Subject: Traffic Safety Committee Report of November 5, 2014

Traffic Safety Committee Report

Wednesday, November 5th, 2014

Photo : Arcadia, looking south

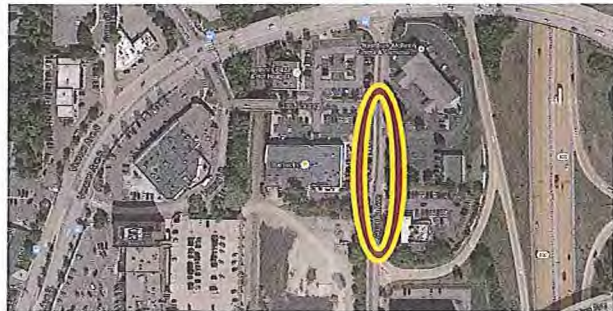
A1. Request for mitigation of drive-thru queue on Arcadia, from Starbucks

The requestor states that the Starbucks' drive-thru queue consistently is long enough for cars to be stopped on city streets, both Arcadia and Gus Young Lane. The requestor feels that this is an issue because the road is not wide enough for queued cars to be passed on their side of the centerline, and this leads to drivers crossing a double yellow line, violating expectations from drivers. In site visits queues were present in both directions, with both left-turning (northbound) and right-turning (southbound) queues appearing on their respective right hand sides of the roadway. In discussions with property management and Starbucks management, it was made clear that they were aware of the issue and had exhausted all their possibilities in dealing with the situation. Arcadia has 1186 AADT just north of this location, and Gus Young Lane has 4275 AADT in this location, with 85th-percentile speeds of 20 and 22 mph respectively. Arcadia in this location is 29.5 feet wide.

After review, staff recommends increased police enforcement and ticketing any driver who is illegally passing.

Map : Traffic Control in the area

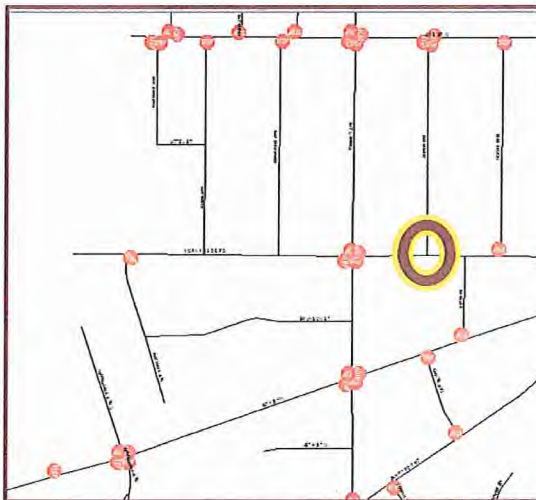
B4. Request for stop sign on Alden at Morningside

This request comes from a resident on Morningside, who believes that drivers speed down Alden and turn onto Morningside at high speed. This makes it difficult for the requestor to back out of the driveway of the residence the requestor occupies. The request for a stop sign was seen as a solution to allow for larger gaps for leaving the driveway. Other solutions were also proposed, and were seen as able to help the scenario, such as bringing the trash cans further into the driveway. A preconstruction count along Alden showed an AADT of 257 and an 85th-percentile speed of 22.3 mph. There are no reported accidents in this location. Warrants for stop signs are attached in appendix A.

After review, staff recommends denial of this request. This decision was due to not meeting warrants for a stop sign.
